Memorandum

To	Le' Ann Whitehouse Seely, OALA, CSLA	Page 1
CC	Jana Joyce Associate, MBTW Group	
Subject	Gore Park Pedestrianization: Grading Review	
From	Ian Izzard, P.Eng., M.A.Sc. Project Manager	
Date	May 17, 2012	Project Number 60225470

KING STREET EAST
GORE PARK PEDESTRIANIZATION
GRADING REVIEW
CENTRAL GARDEN
From : James Street South
To : Hughson Street South

To	Jana Joyce, MBTW-Watchhorn	Page	1 of 4
CC			
Subject	Gore Park Utility review		
From	Ian Izzard		
Date	September 06, 2012	Project Number	60225470

KING STREET EAST
GORE PARK PEDESTRIANIZATION
GRADING REVIEW
MACDONALD SQUARE
From : John Street South
To : Catharine Street South

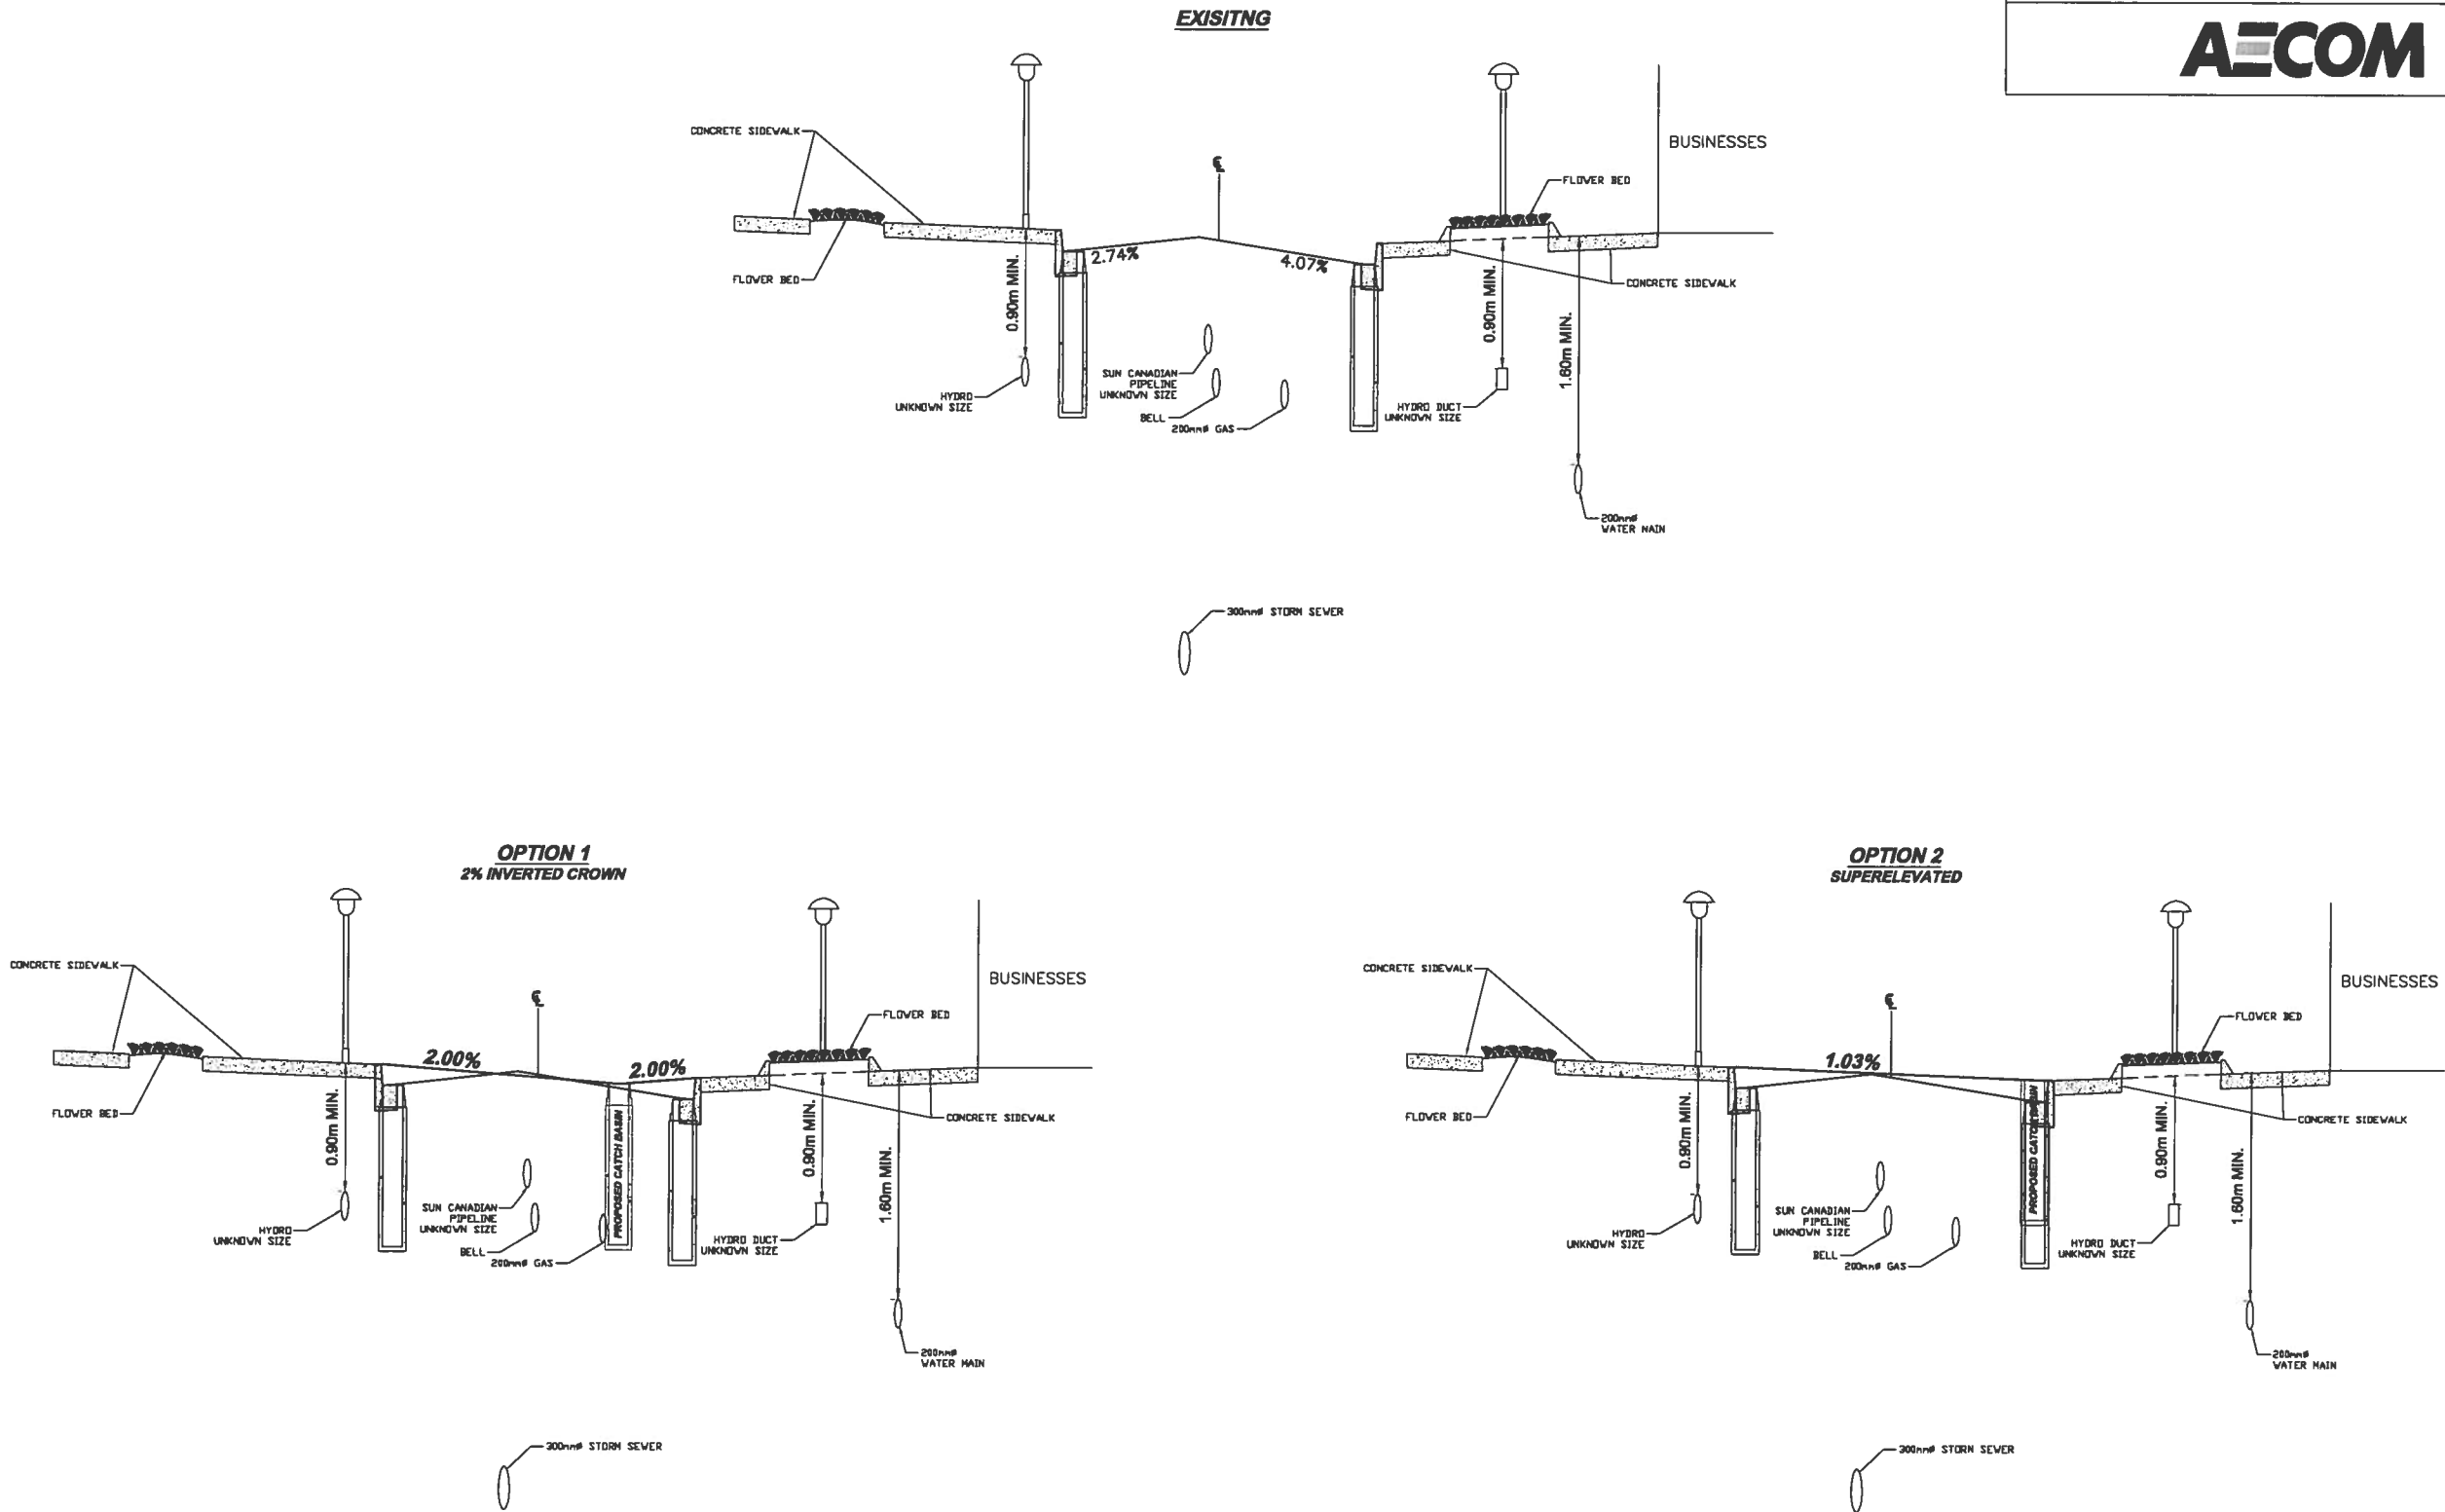
This section of the park runs from John Street to Catharine Street. The existing roadway is built with a cross slope of approximately 2.5% to the south. There is a 150mm gutter on the south side of the street; the North side of the rolling surface is flush with king Street. Two options were reviewed for the Pedestrianization of this block:

Inverted crown	Full cross slope
Pedestrianization	Proposed road surface is flush with the existing sidewalk and curb	Proposed road surface is flush with the existing sidewalk and curb
Sub drains	New sub drain will have to be installed under the low point in the road to ensure drainage of the stone base under the road.	Roadway sub drain will remain in its present location and will ensure drainage of the stone base under the road.
Cross slope	2% cross fall as per City standards	1.3% cross fall, does not meet City standards
Water storage	Water storage from heavy storm may back-up within the existing roadway before it approaches the building.	Water storage from heavy storm may back-up on the sidewalk and approach the existing buildings.
Catch basins	Existing catch basins will be removed and replaced with new catch basins at the low point in the roadway.	Existing catch basins can remain in their existing location and be raised to the elevation of the proposed Pedestrianized road. Additional catch basins will be required between the existing catch basins.
